TECHNICAL NOTE

Reference: Sailplane type: Standard Libelle,
Standard Libelle 201 B
German Data Sheet No 251, all Serial Numbers

Subject: Pedal control

Nr: 201 - 16 e

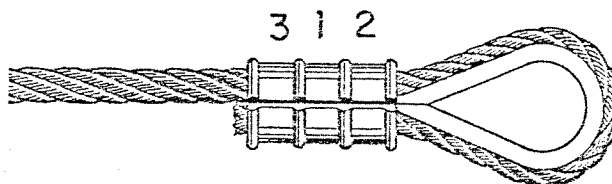
For the oval sleeves No 28-3-M three compressions are required. Make the center compression first, the compression next to the thimble second, and the one farthest from the thimble last. It is desirable to place

the oval sleeve in close proximity to the thimble points, so when compressed the sleeve will contact the thimble as shown below. The sharp ends of the thimble may be cut off before using; however, make sure, the thimble is firmly secured in the cable loop after the splice has been completed.

The completed sleeves should be checked periodically with the proper gauge. Hold the gauge so that it contacts the major axis of the sleeve. The compressed portion at the center of the sleeve should enter the gauge opening with very little clearance, as shown below. If it does not, the tool must be adjusted accordingly.
